CRAIGIEBURN WEST PRECINCT STRUCTURE PLAN

PASK GROUP - VARIOUS PROPERTIES

STATEMENT OF EVIDENCE BY ANDREW CLARKE ON PLANNING ISSUES

APRIL 2020

Plan 1: Reconfigured PSP

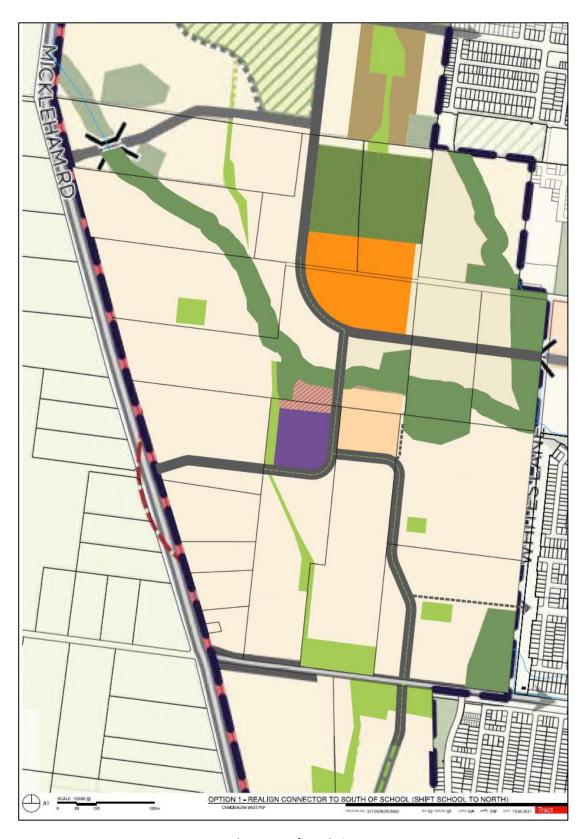
The diagonal connector road will lead to inefficient subdivision design by creating lots that are not aligned on the north-south east-west axes to maximise solar access and /or by creating awkwardly shaped and sized lots. It is preferable that the connector road follow a more north-south alignment.

Plan 1 (over page) indicates how the PSP could be amended to give effect to the above changes, namely:

- A reduction in the area of the Craigieburn Road local park (LO9);
- Slight northward relocation of the primary school;

- Removal of Park L08/L06; and
- A more conventional orientation of the connector road.

I consider that the Advisory Committee should recommend these changes.

Plan 2: Alternative Density Plan (note the connector road location differs from Plan 1)

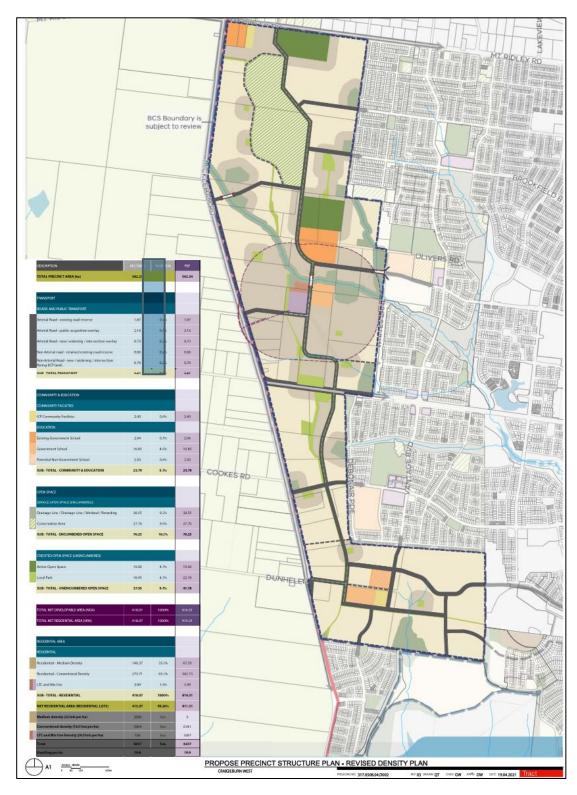
Tract have prepared a plan (Plan 2 over page) which identifies a greater spread or distribution of medium density housing not only within the walkable catchment around the town centre but around other amenity features such as local parks so that the density obligation is distributed more equitably.

The 20 dwellings/ha target is not confined to any specific part of the PSP or the PSP as a whole but across all of metropolitan Melbourne's growth areas. The alternative plan (Plan 2) which depicts 22 dwellings/ha within the walkable catchment and around the local open spaces achieves this outcome.
